## **Errata: EDB9312**

This errata contains the full text and drawings for two Engineering Change Notices (ECN) from Videon. These are Videon ECN # CM-0306-24 and CM-0403-05. Both ECNs describe modifications needed on the EDB9312 circuit board. These ECNs provide all details needed to update existing boards to the new modification level.

<h2 style="margin: 0;">Engineering Change Notice</h2>	ECN No. <span style="border: 1px solid black; padding: 2px 10px; display: inline-block;">CM-0306-24</span>
--	--

<h2 style="margin: 0;">Engineering Change Notice</h2>	ECN No. <span style="border: 1px solid black; padding: 2px 10px; display: inline-block;">CM-0403-05</span>
--	--

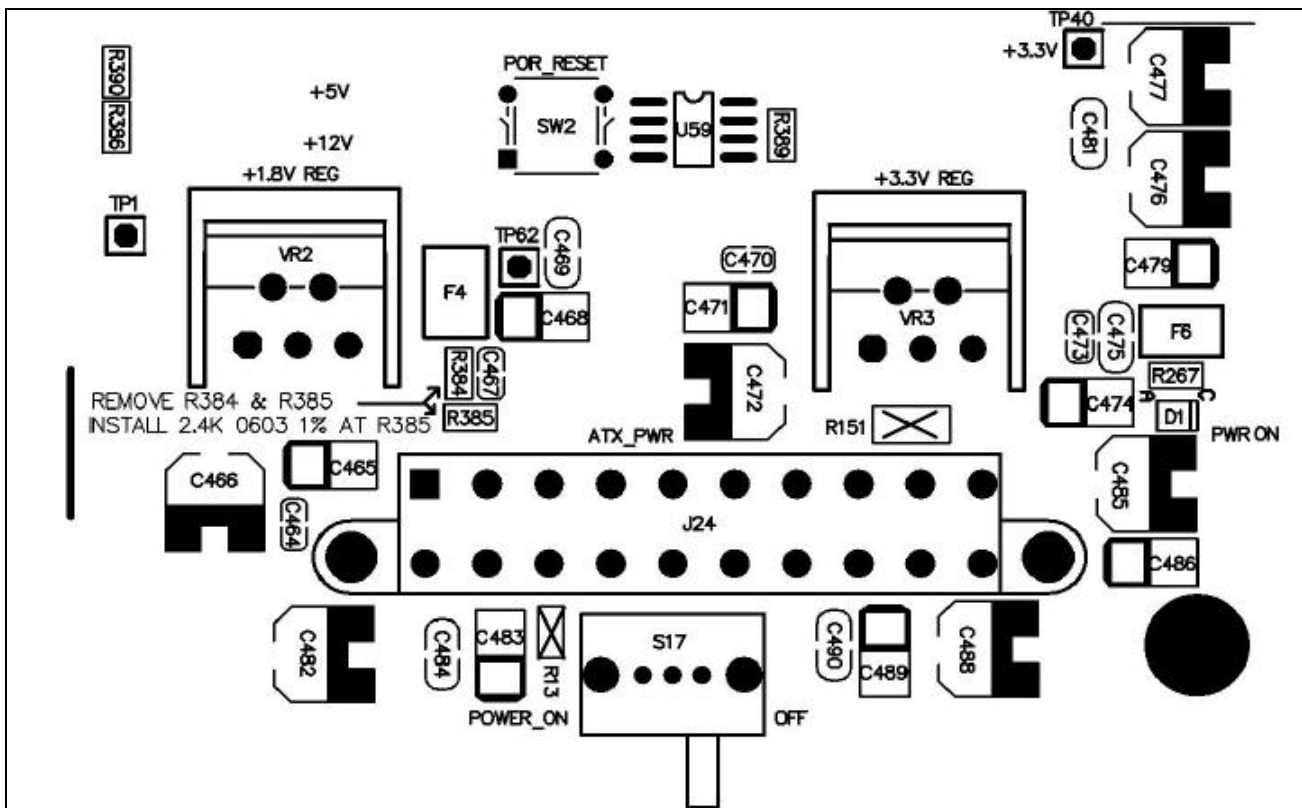
<b>Brief Description of Problem:</b> (Engr.) The 1.8v power supply sags/dips to an unacceptable voltage level under heavy processor load. The fuse and board layout account for a large enough voltage drop such that the minimum voltage requirements of the EP9312 are not met.
<b>Description of Change:</b> (Engr.) Recommended Solution- Replace the 1.8V regulator with an adjustable one to achieve 1.9V output. Use a sense wire from this voltage regulator's ADJ pin to sense the voltage at the load (i.e. the EP9312 device).  <u>Change required to solve the problem:</u> Remove 1.8V regulator VR2 from the board and also remove the heatsink from this regulator. Replace this regulator with an adjustable one Part # LT1764AET and install the heatsink on this device. Remove R384, R385 on the component side near the 1.8V regulator (VR2) and install a 2.4K ohm 0603 1% resistor at R385. Leave R384 unpopulated. Install a 1.4K ohm 1206 1% resistor to the regulator pin 5 on the bottomside. Remove C20 and C38 on the bottom side near the EP9312 device and replace with 100uF TC tantalum caps (Vishay Part # 595D107X9010C2T) or equivalent. Add 2 additional caps (100uF TC as above) between JP2-p2 and JP105-p26 Attach a wire (22 AWG) on bottomside of board from JP2-p1 to the other end of the 1.4K resistor placed on pin 5 of the new regulator and glue in place. Mark change on board at assembly revision block making the new rev 2A.  These changes are illustrated on page 2(bottom view) and page 3 (top view).
